Access Compliance Report

Public Rights-of-Way

(Curb Ramps)

Intersection ID: 15377	Main Street: ELMHURST_RD	Cross Street: HAVERFORD_PL	Location:	N
ADA ID: 812EFBEB5DB8	Ramp Type: Directional1	Initial Pass/Fail: Fail	Overall Compliance: No	Severity Score: 1.25
Codes/Mitigation Info/Possible Solution		Field Measurements/Component Compliance

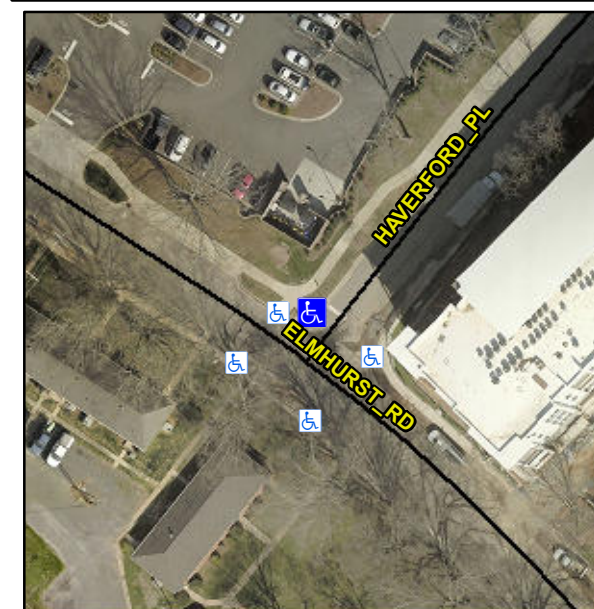
R304.5.3

Remove & Replace Entire Ramp.
